CERTIFICATE OF APPROPRIATENESS

Property: 527 Frasier Street, Lot 3, Block 7, Freeland Neighborhood Subdivision.
The property includes a historic 1,359 square foot, one-story wood frame single-family residence and a detached garage situated on a 5,000 square foot (50' x 100') interior lot.

Proposal: Alteration: Front Porch & Windows

March 16, 2023 (Rear Elevation of Addition) – Inspector’s Photos

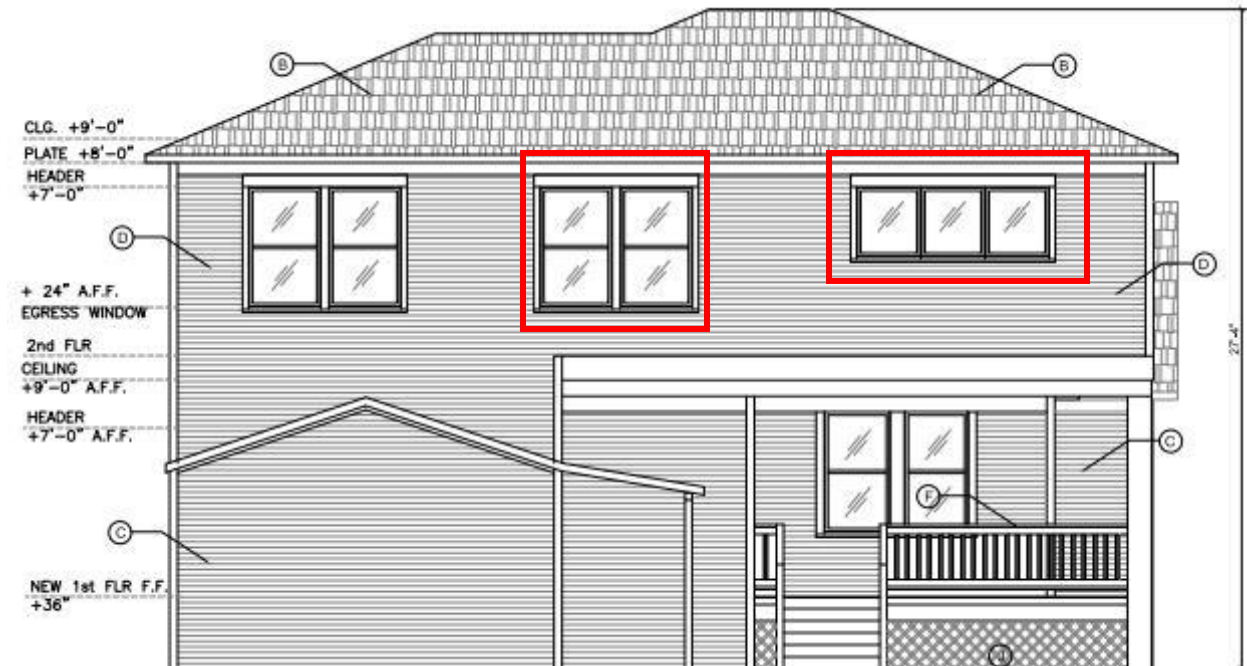
- Site visit by inspector from Houston Permitting Center found vinyl, fin mounted windows installed on rear addition.
 - Staff received email from inspector March 16, 2023
 - Staff contacted agent regarding situation
 - Staff conducted site visit on March 22, 2023 to inspect vinyl windows and discovered additional alterations had taken place not in approved COA for fenestrations on rear addition along with alteration to front porch and removal of windows on right elevation of historic structure that were not in the proposed scope of work.
See photos
- Staff emailed (3-29-2023) agent and applicant that revised drawings are needed and must return to HAHC for consideration
- Replace already installed vinyl windows with double-hung, 1-over-1, inset & recessed, wood windows
- Replace already installed fixed vinyl windows with fixed, inset & recessed, wood windows

May 18, 2023 – Proposed Right Elevation

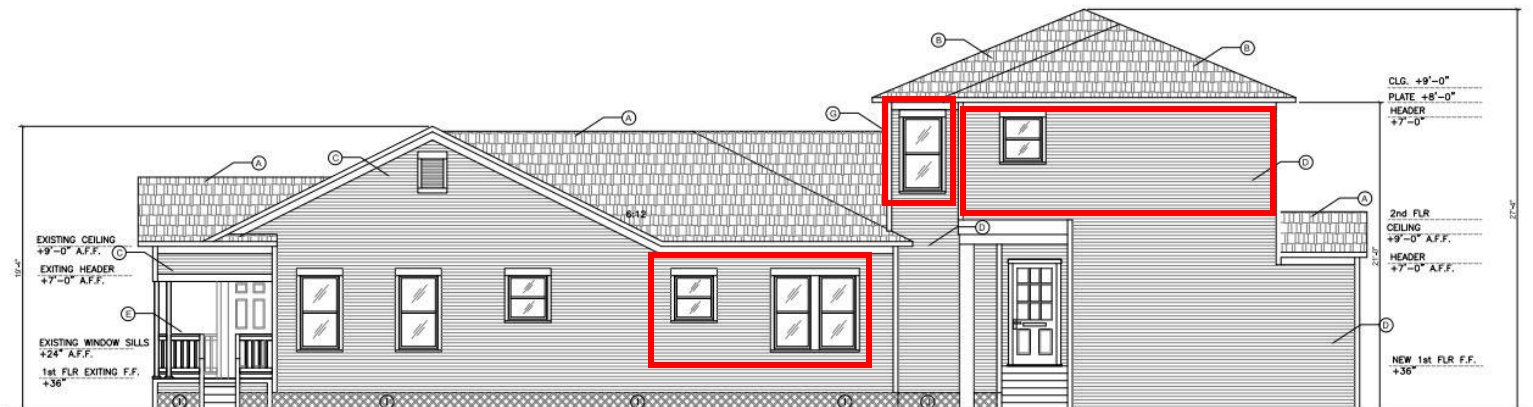
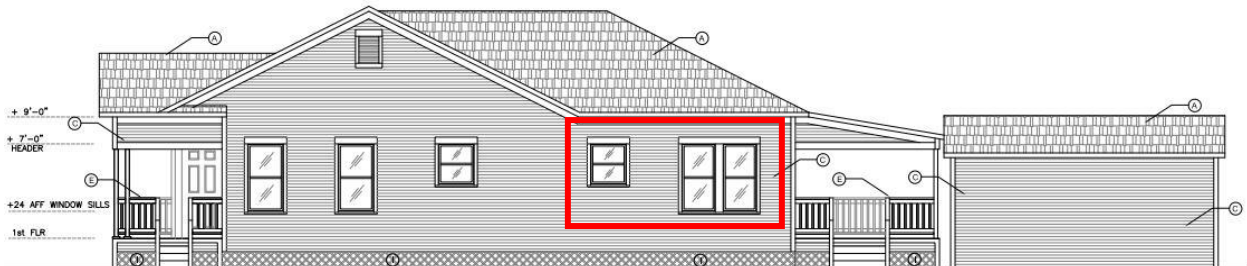
Recommendation: Denial of COA. Issuance of COR for work completed and as submitted with the condition that the new window on the right elevation be relocated to the location shown on right side elevation drawing.
